Report to the Future Melbourne (Planning) Committee

Agenda item 6.1

Planning Permit Application: TP-2020-274
54-62 Bourke Street, 11-19 Liverpool Street and
Shop 9, 10-26 Crossley Street, Melbourne

8 December 2020

TITLE
**PROPOSED ELEVATIONS -
LIVERPOOL ST - STAGE 2**

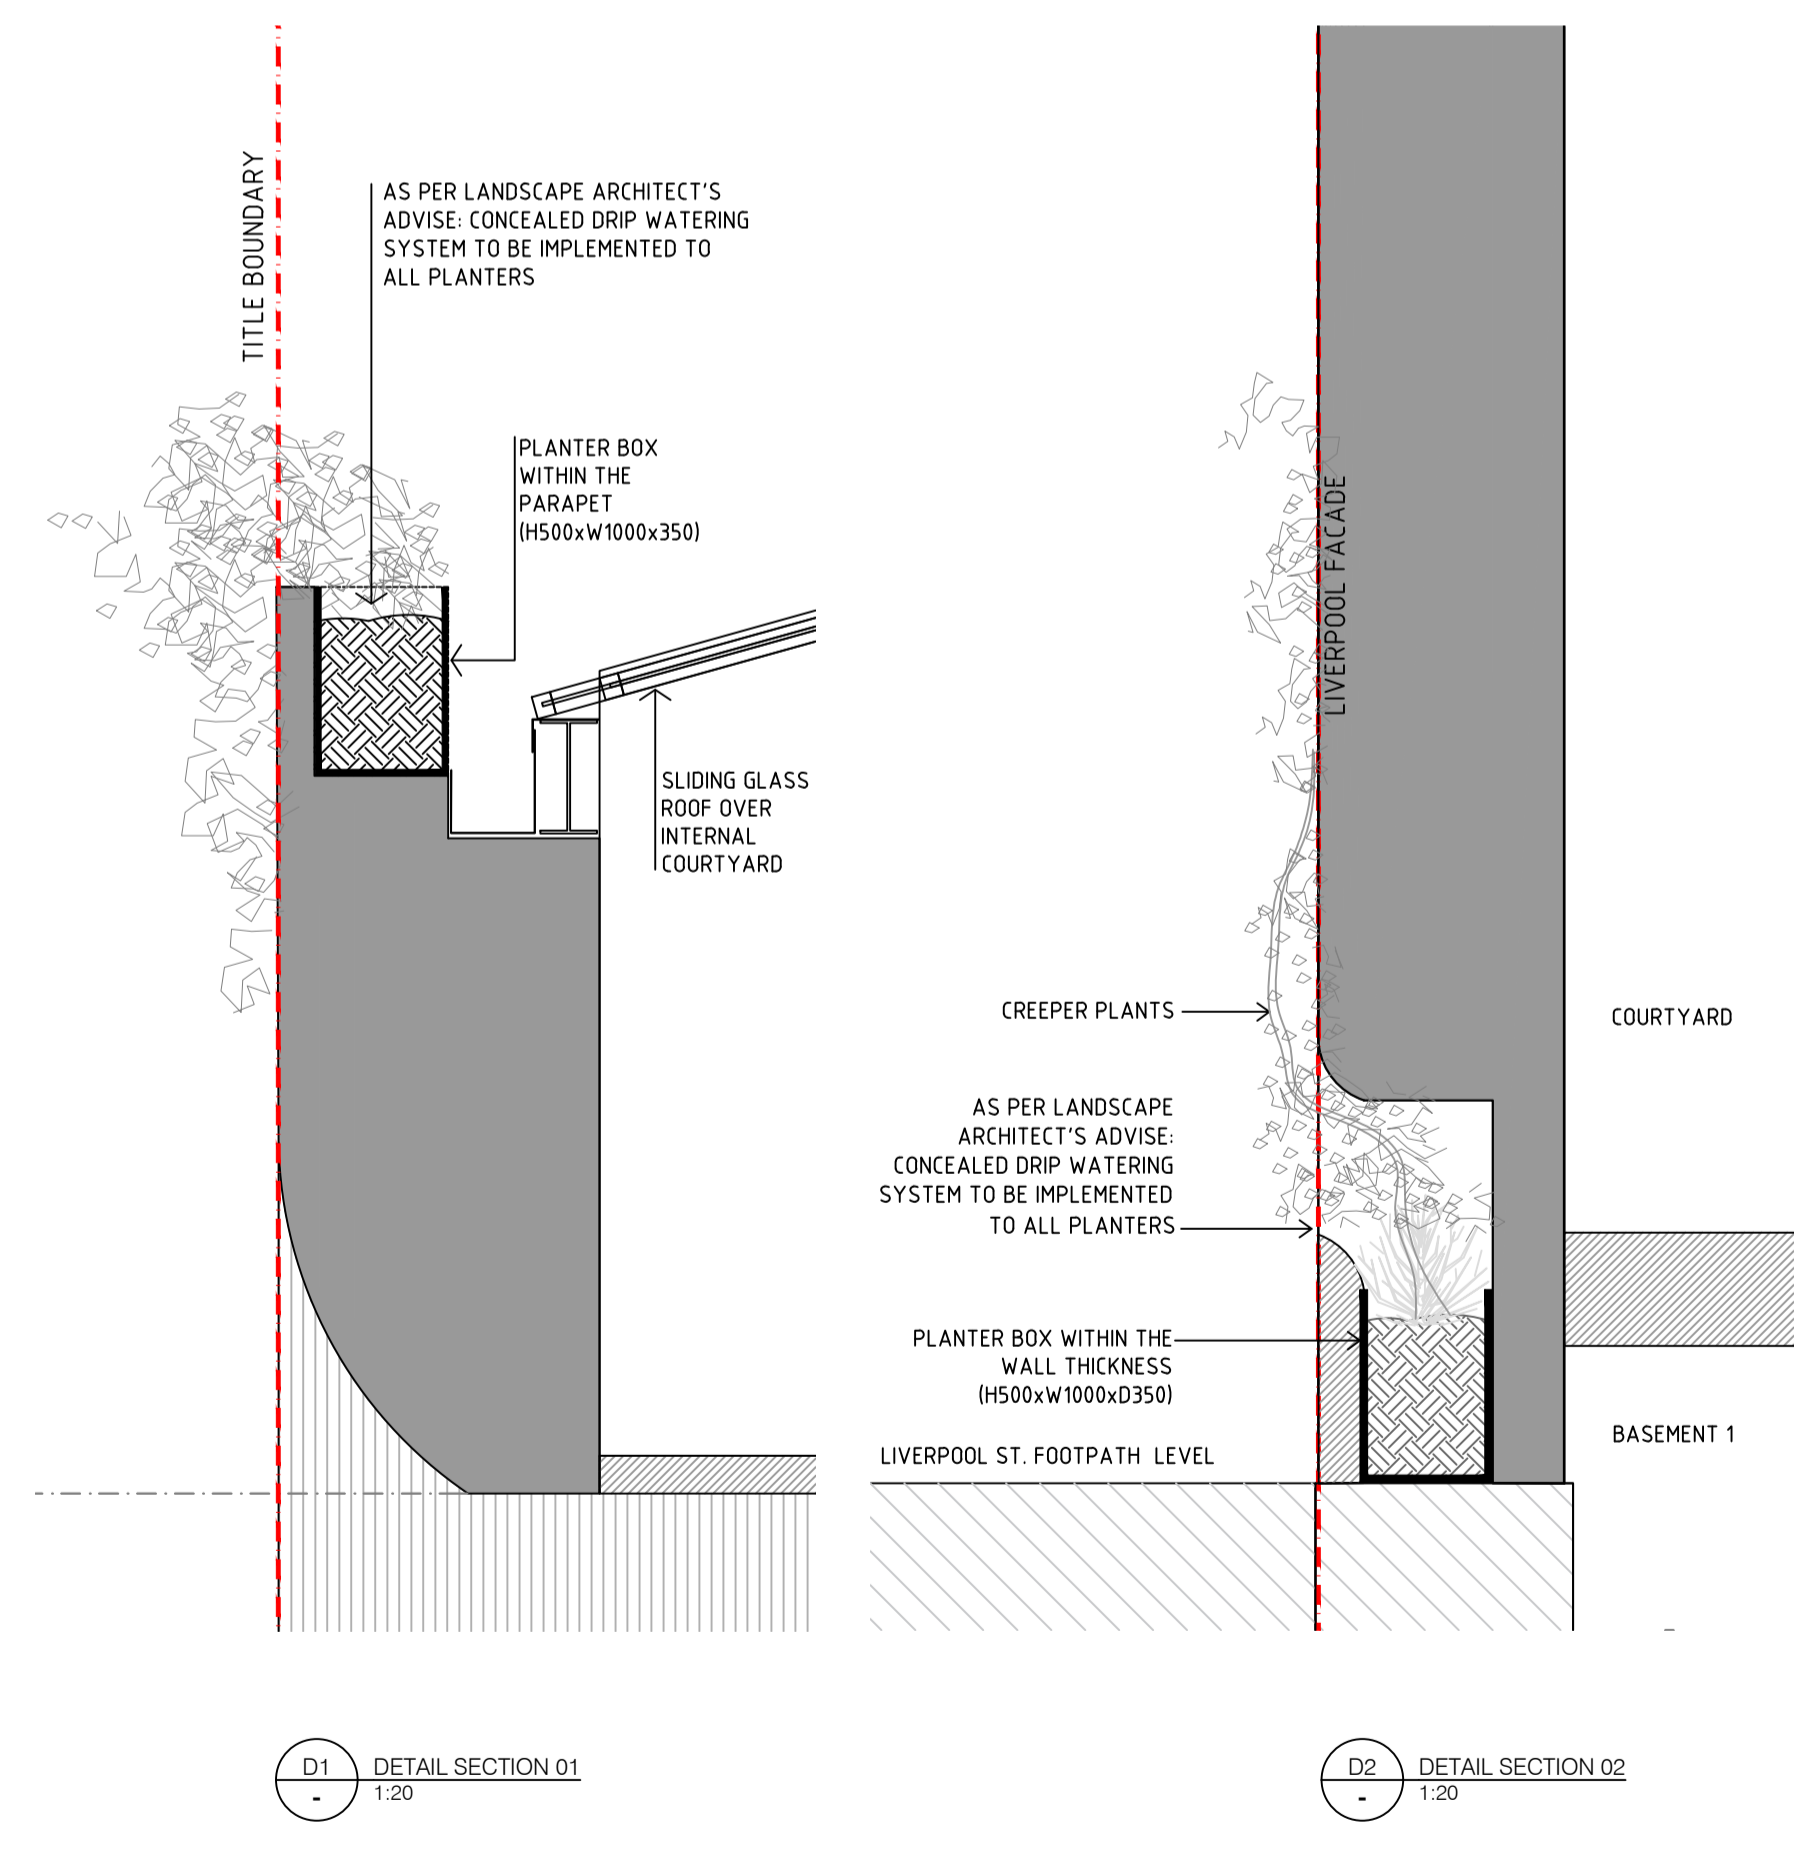
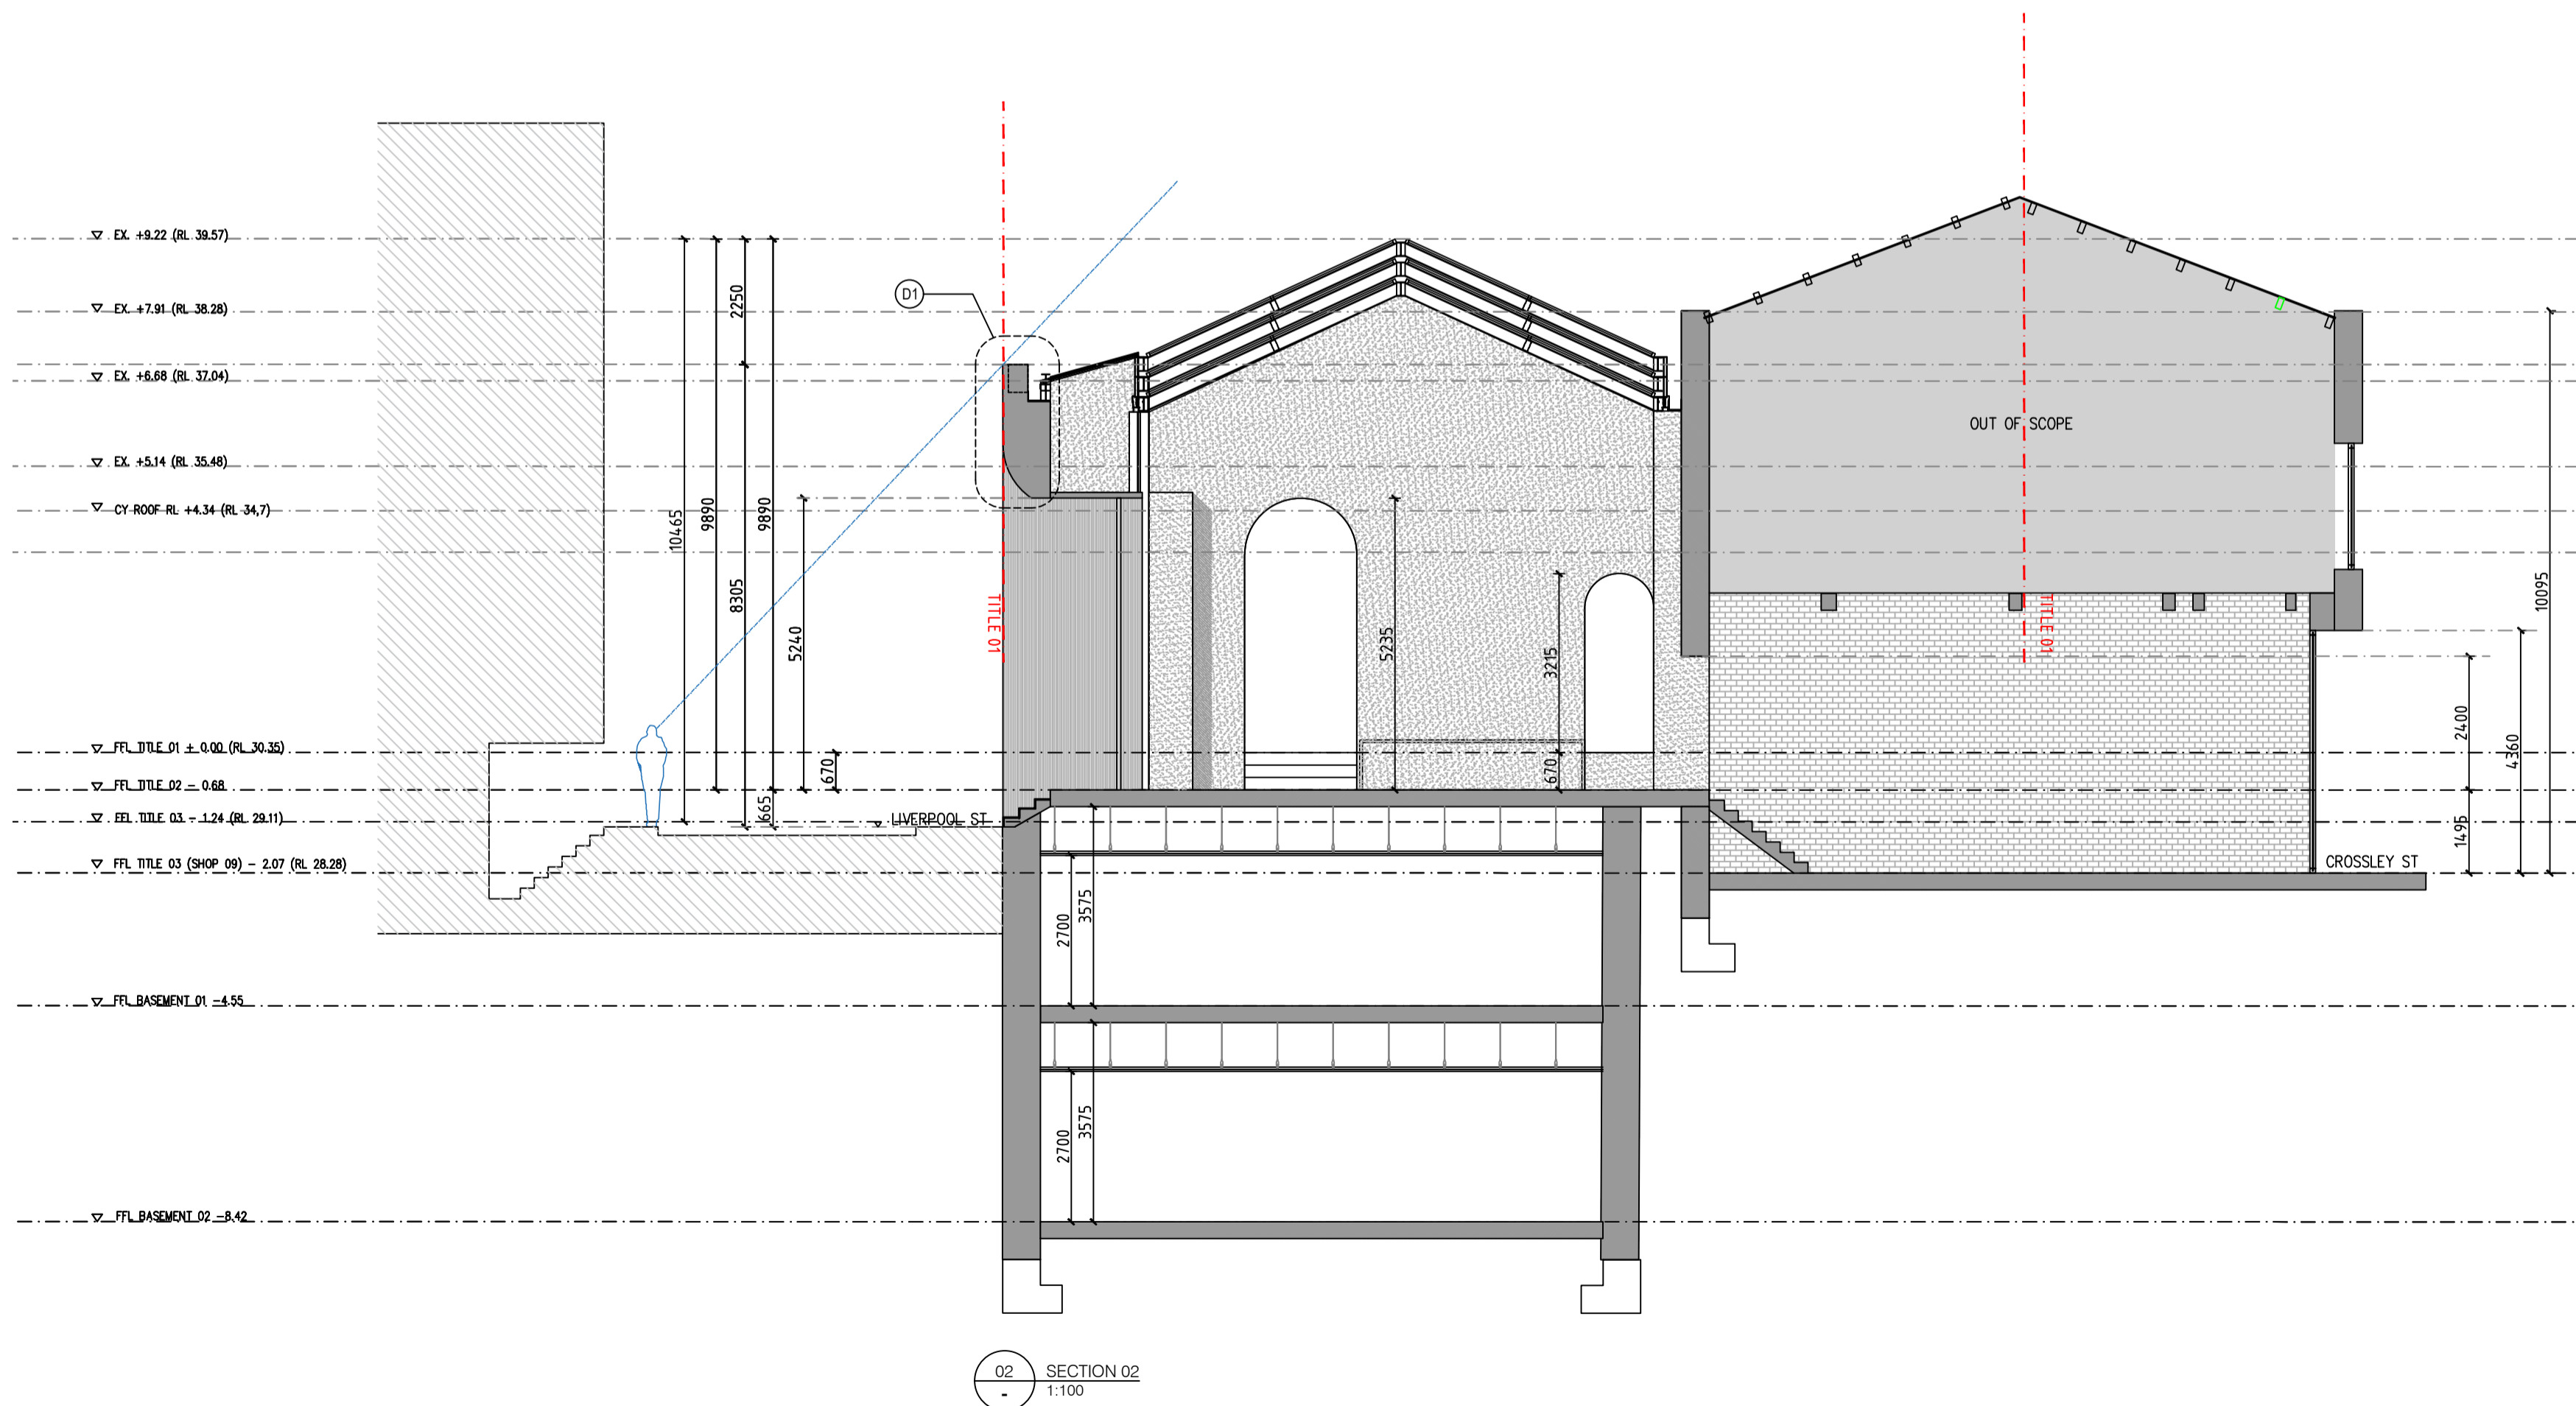
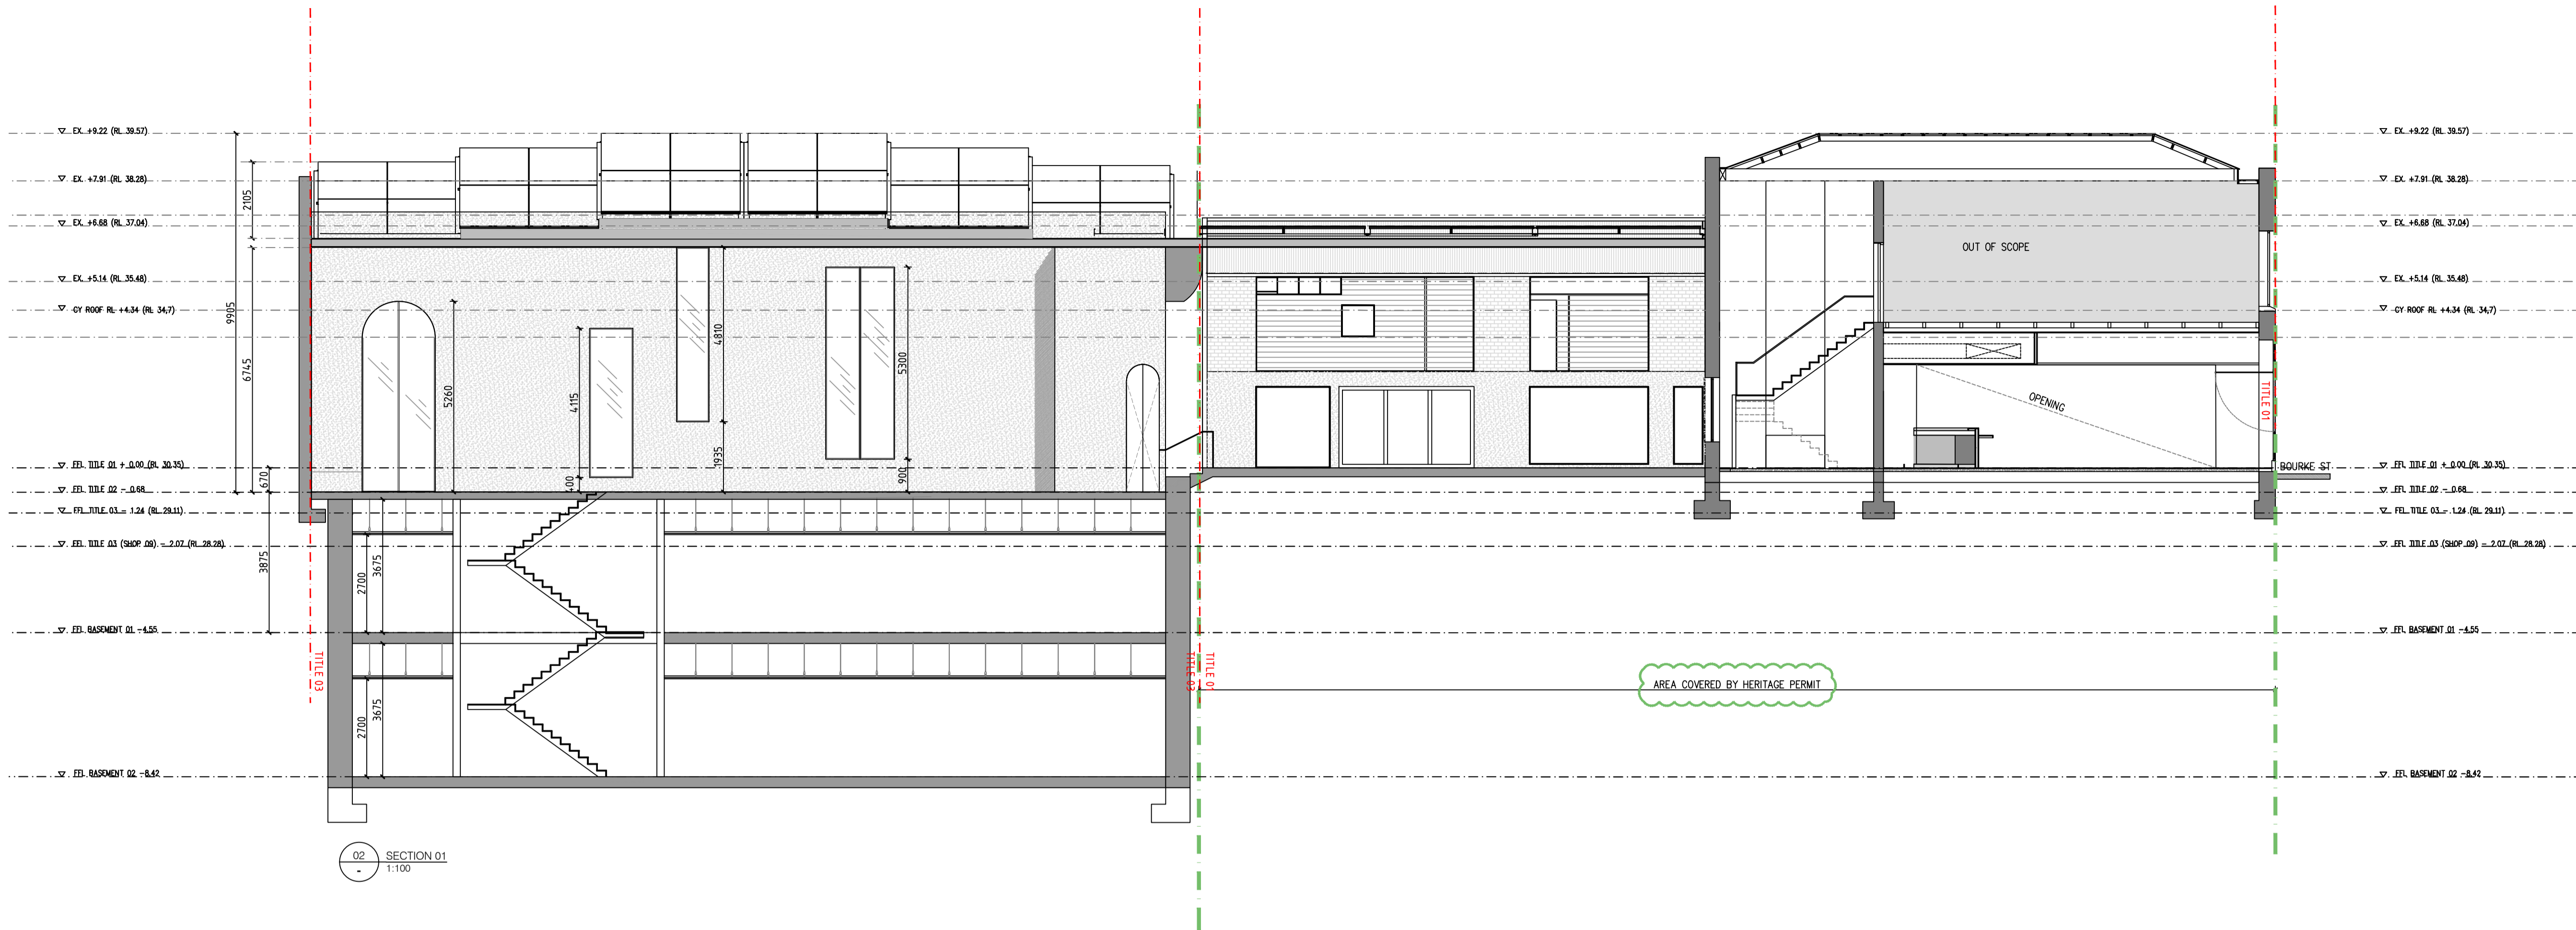
- Discrepancies exist between the submitted plans and aspirational images and as such further information is required with regard to the precise presentation of the Liverpool Street wall. This includes sections taken through its various openings to better understand how it curves and transitions to outdoor seating elements.

- Operable mesh should be provided across the planter gaps of the wall to create added visual interest in the event plantings fail in the future. This mesh should be finished to match the steel frame of the roof and matt black finish of the windows and its spacings should be large enough for plants to grow through but small enough to deter the placement of foreign objects (such as litter).

Though the Liverpool Street wall (refer Figure 6) does not reflect a typical or commonly accepted design approach, it will nevertheless create visual interest and assist in activating the streetscape. Importantly, this activation is not wholly explicit and includes subtle elements such as integrated seating and landscaping. These initiatives have been endorsed by Council's Urban Designers.

In addition to this, it is also recommended that a mix of climbers, creepers and native species be planted. Such a mix would further soften the appearance of the wall.

Figure 9: Shadows cast by existing buildings over Liverpool Street at 1pm (left hand image) and 2pm (right hand image) on 22 September (source: application plans prepared by Point Architects)

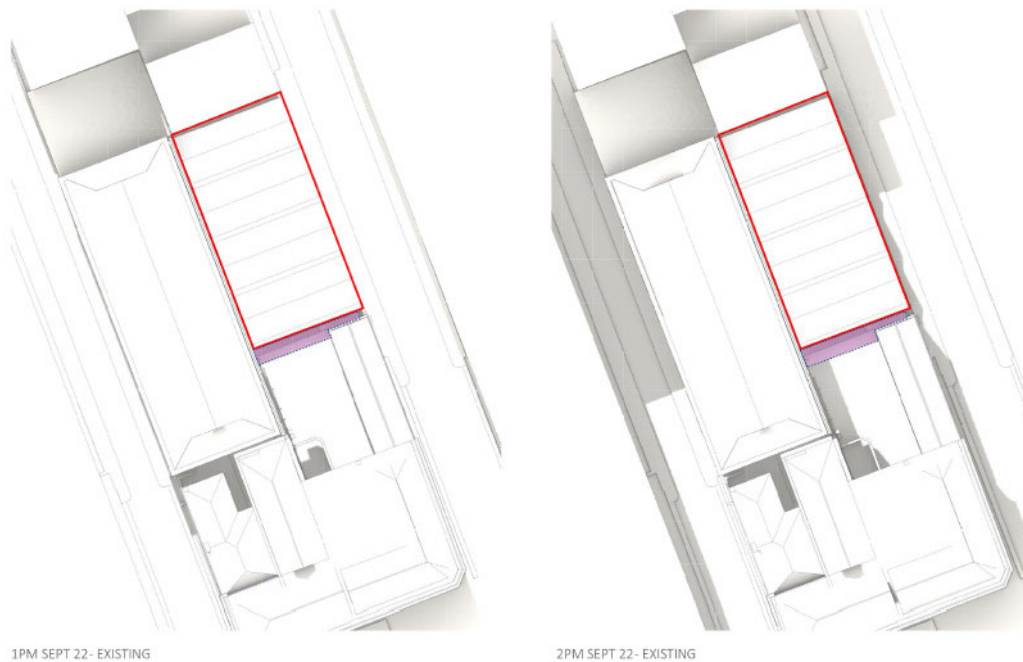
Figure 9 below shows the shadows currently cast by existing buildings over Liverpool and Crossley Streets at 1pm and 2pm on 22 September. Given the orientation of the site, no

shadows are cast over either street at 1pm and only limited shadows are cast over Liverpool Street at 2pm.

Figure 10: Shadows cast by the proposed building over Liverpool Street at 1pm (left hand image) and 2pm (right hand image) on 22 September (source: application plans prepared by Point Architects)

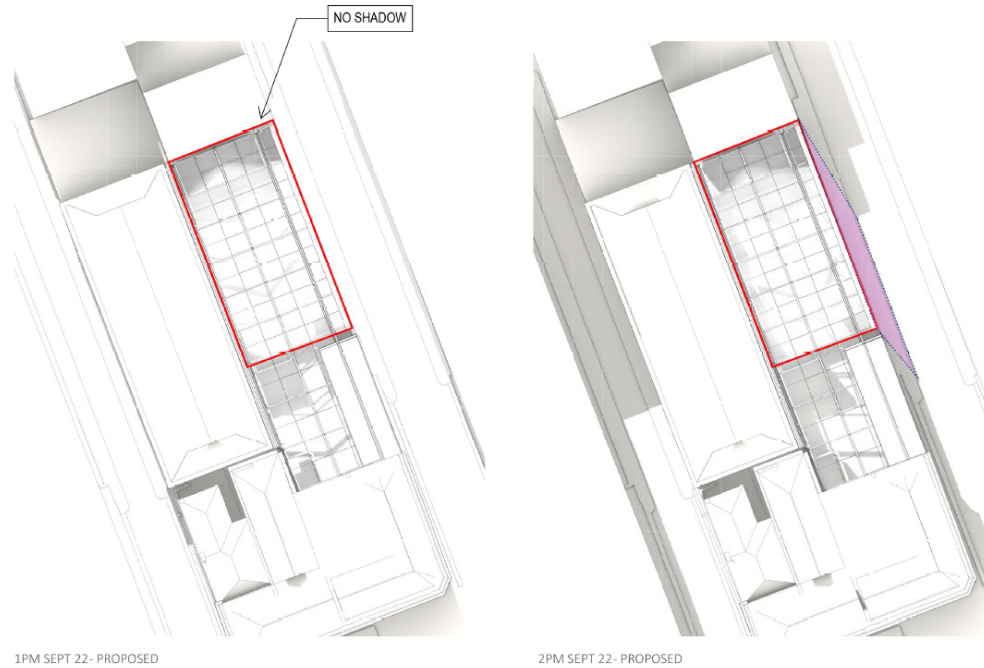
Figure 10 below shows the shadows the proposed building would cast over Liverpool Street. Again, given the orientation of the site and fact that no new forms would be constructed along the Crossley Street frontage, no additional shadows would be cast here.

On the basis these additional shadows would extend only a short distance beyond those cast by existing buildings, it is considered the amenity of the street would not be unreasonably reduced.

Importantly, these additional shadows would not extend much beyond the footpath running along the western side of the street and not across the remaining width of the carriageway and street trees extending along its eastern side. Shadows would also be cast after 1pm only and therefore the street would remain clear of overshadowing for the majority of the times specified by Clause 22.02. When shadows do then extend over the street, these would again be limited and not extend over key landscape features.
